<https://www.emnrd.nm.gov/ocd/contact-us/>State of New Mexico
Energy, Minerals and Natural ResourcesForm C-103
Revised July 18, 2013OIL CONSERVATION DIVISION
1220 South St. Francis Dr.
Santa Fe, NM 87505

SUNDRY NOTICES AND REPORTS ON WELLS (DO NOT USE THIS FORM FOR PROPOSALS TO DRILL OR TO DEEPEN OR PLUG BACK TO A DIFFERENT RESERVOIR. USE "APPLICATION FOR PERMIT" (FORM C-101) FOR SUCH PROPOSALS.) 1. Type of Well: Oil Well ☒ Gas Well ☐ Other ☐		WELL API NO. 30-025-29226 5. Indicate Type of Lease STATE ☒ FEE ☐ 6. State Oil & Gas Lease No.
2. Name of Operator SPUR ENERGY PARTNERS LLC on OCD's behalf of Energy Acumen LLC		7. Lease Name or Unit Agreement Name SHELL STATE
3. Address of Operator 9655 KATY FREEWAY, SUITE 500, HOUSTON, TX 77024		8. Well Number 1
4. Well Location Unit Letter J : 1650 feet from the SOUTH line and 2310 feet from the EAST line Section 10 Township 17S Range 33E NMPM LEA County		9. OGRID Number 328947
11. Elevation (Show whether DR, RKB, RT, GR, etc.) 4156.9' GL		10. Pool name or Wildcat MALJAMAR; GRAYBURG-SAN ANDRES

Shell State 1 P&A Procedure

Re: Oil Conservation Division Authorization for Spur Energy Partners, LLC to Plug and Abandon Well(s)

API #	30-025-29226	PROPOSED P&A SHELL STATE 1	County, ST	Lea County, NM
Operator	Energy Acumen LLC		Sec-Twn-Rng	10-17S-33E
Field	Grayburg-San Andres		Footage	1650 FSL, 2310 FEL
Spud Date	6/3/1985		Survey	32.846508, -103.6500397

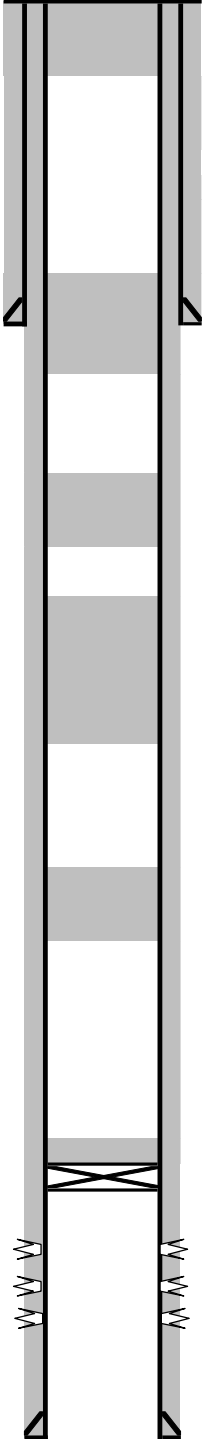
Created By	Condition	Condition Date
loren.diede	Notify NMOCD 24 hours prior to beginning P&A operations.	9/19/2024
loren.diede	Submit CBL into NMOCD Imaging via Electronic Permitting.	9/19/2024
loren.diede	Modify the Yates formation plug to cover the Yates top picked at 2772'. (The 2722' top in procedure is a typo).	9/19/2024
loren.diede	Modify Plug # 4 or add a plug to cover the Rustler (Anhydrite) formation top at 1470' with a plug from 1520' to 1420'.	9/19/2024
loren.diede	NMOCD considers this well to be within the proximity of the LPCH restricted area and therefore a below-ground P&A marker will be required.	9/19/2024
